# Waterloo Metro Quarter Southern Precinct Modification 1

Changes to student housing tower and open space areas  
State Significant Development Modification Assessment  
(SSD 10437 MOD 1)

August 2022

Figure 4 | Proposed ground floor plan

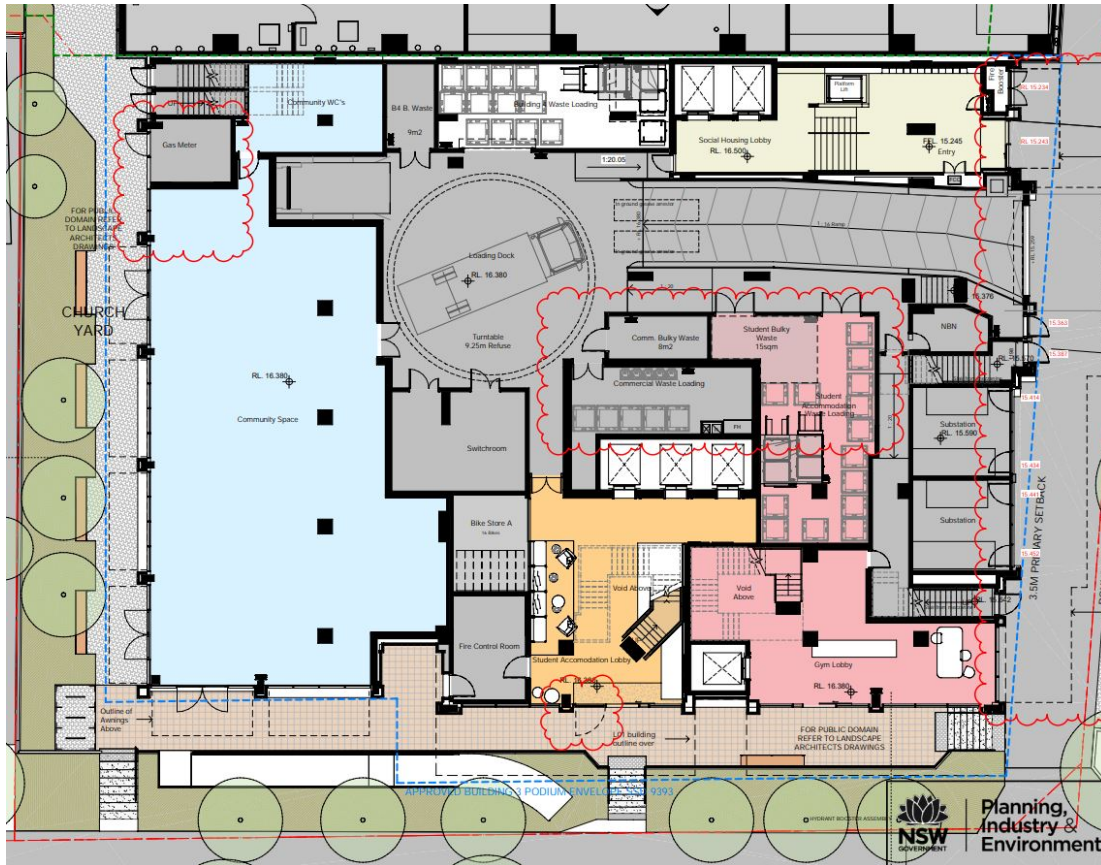
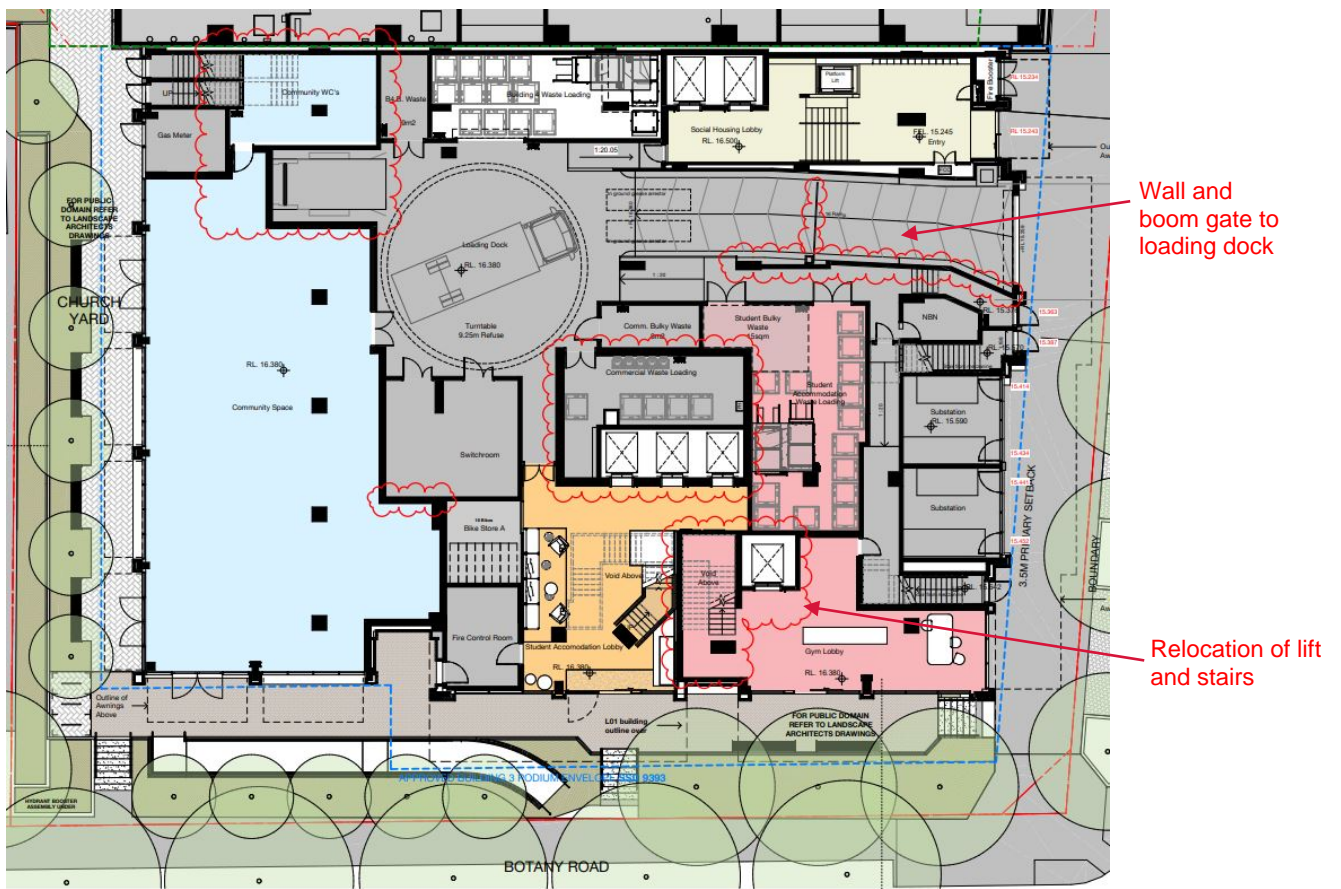
- Reconfiguration of lift cores, service areas, and stairs for the gym and student housing tower (**Figures 3 - 6**)
- additional block wall and boom gate to the loading dock driveway (**Figures 3 and 4**)
- additional height and area for plant zone on the roof (**Figures 7 and 8**)
- landscaping revisions to the Level 2 external terrace (**Figures 9 and 10**)
- additional louvres at the Ground Floor, Level 1 and Level 2 (**Figure 11**)
- additional small louvre to the west elevation of the Level 24 lift core for fresh air supply.

Council said it raised no issues with the proposed external changes to the plant rooms, louvres or service doors or the internal changes to the student housing podium, gym fit out or driveway.

The Department accepts the proposed internal and external design changes as they are detailed design matters and notes the following:

- the changes are minor and to be expected as a result of architectural and services coordination during the construction certificate phase
- the changes do not affect the overall design quality of the building as viewed from the public domain or surrounding development
- no additional overshadowing of Alexandria Park is present due to the plant rooms being set back from the southern, eastern and western edges of the building.

**Figure 10 |** Proposed Level 2 landscape terrace plan

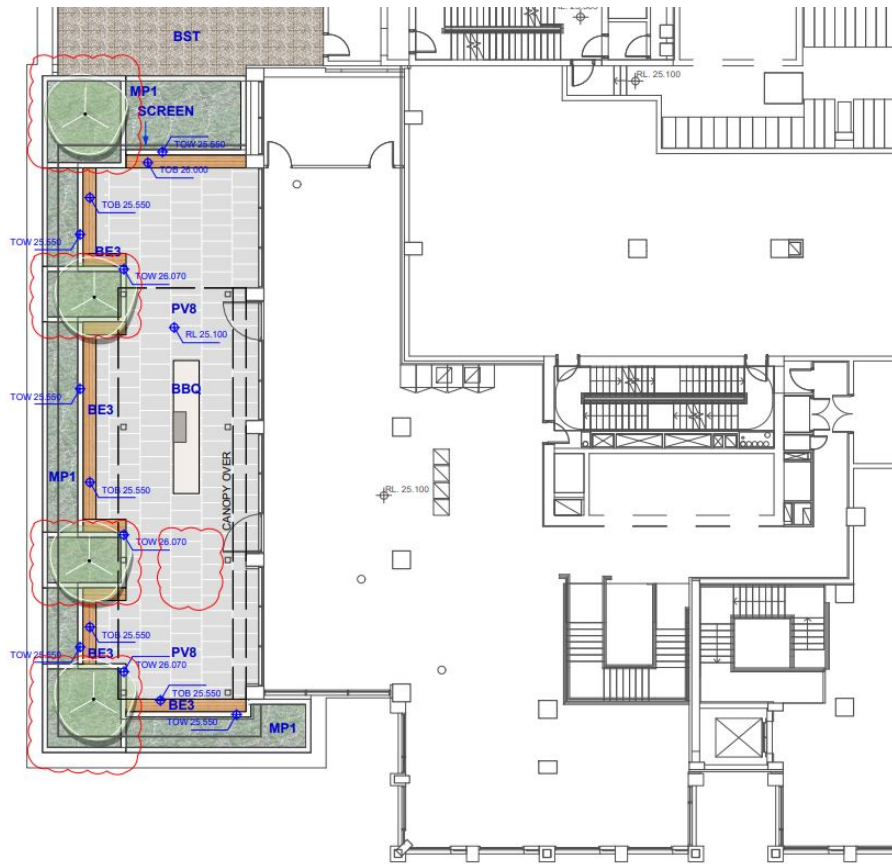
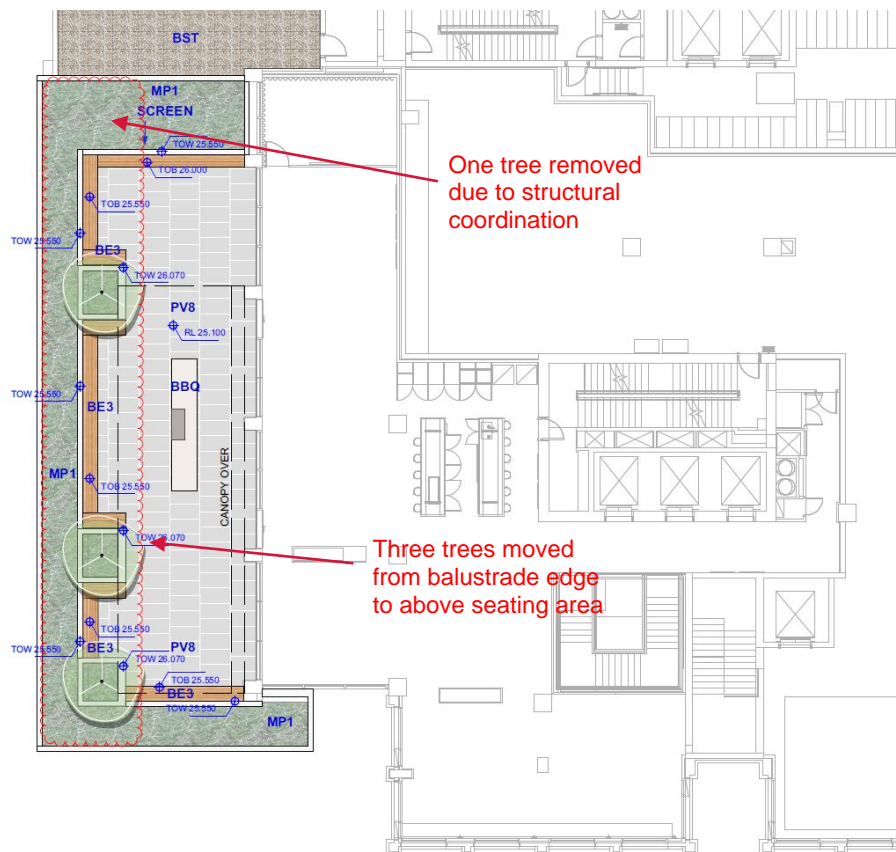
Council said the removal of a tree on the Level 2 terrace due to structural constraints reduces shade for new residents and dilutes the landscape quality of the private open space.

Specifically, in relation to the Level 2 landscaping amendments, the Department notes:

- three instead of four trees remain on the terrace area, and spaced appropriately from each other, providing shade to users of the terrace and barbeque area. In particular, the eastern

most tree is the one proposed to be removed whilst the western trees are maintained for shade from harsh afternoon summer sunlight

- minor loss of tree canopy from removing the one tree is compensated by the additional tree planting in Cope Street Plaza which maintains the overall canopy cover across Waterloo Metro Quarter.

Figure 13 | Proposed ground floor landscape plan

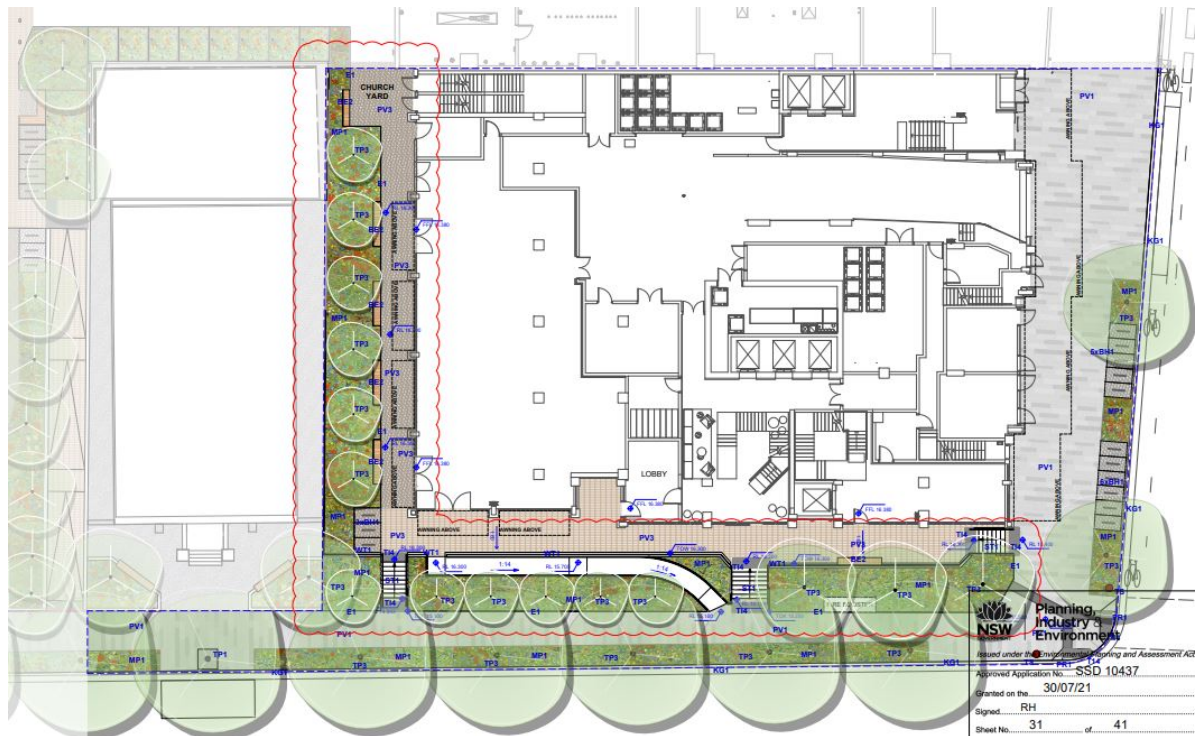
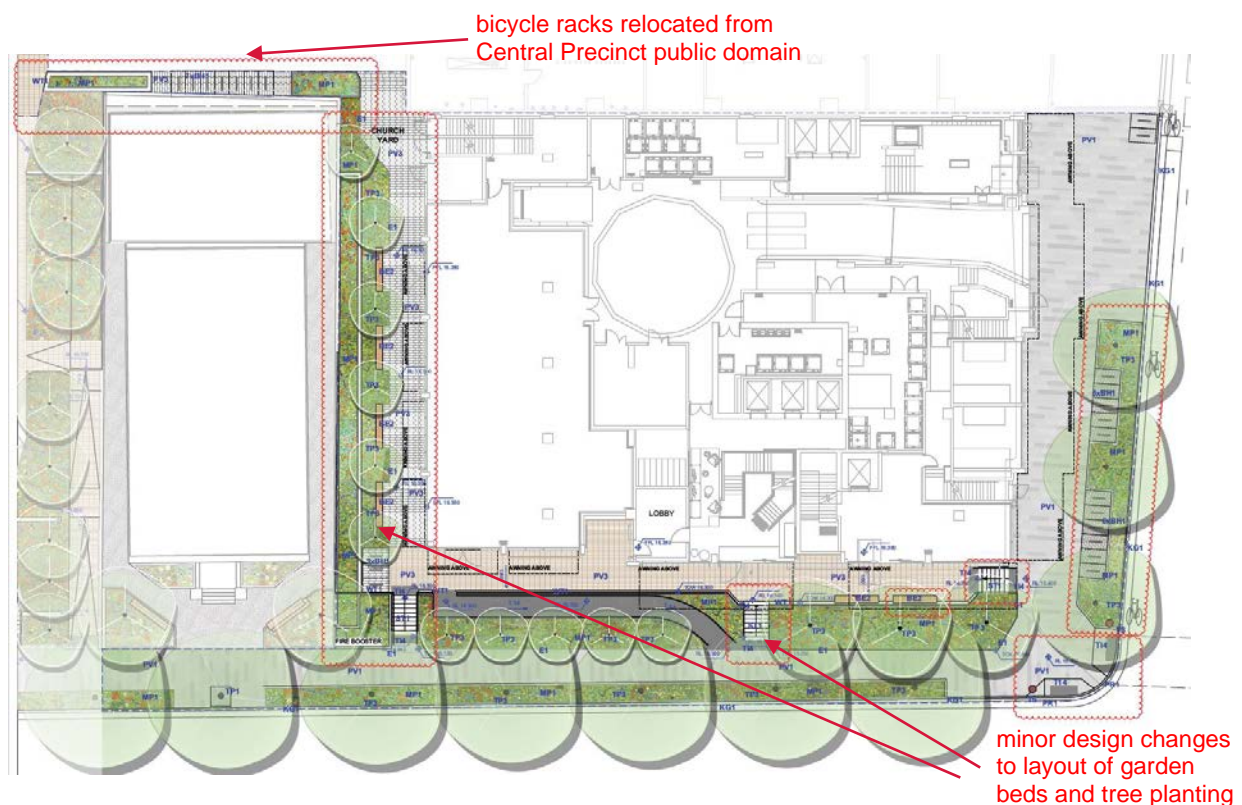
- changes within building setback zones (i.e. publicly accessible open space) including relocation of proposed trees, reconfiguration of garden beds, revised awnings, revised bench seating, and altered stair widths (**Figures 12 and 13**)
- changes to Cope Street Plaza including reconfiguration of garden beds and benches, and additional landscaping along the shared zone to the south of the plaza (**Figures 14 and 15**).

Council said there is a loss of shade and landscape quality due to the inclusion of additional bicycle racks, removal of a pergola in Cope Street Plaza and priority of the shared zone as vehicle access to car parking.

- the 15 bicycle racks are being relocated from the Central Precinct public domain and are not additional racks (**Figure 13**). They will be located behind the adjoining church. Whilst they occupy a space previously identified as garden, there is a net increase in garden space from the proposed changes to Cope Street Plaza.
- there is an increase and improvement in the shared zone landscaping beds at the western end near the Central Precinct and there are no changes to the shared zone access as approved (**Figure 15**).
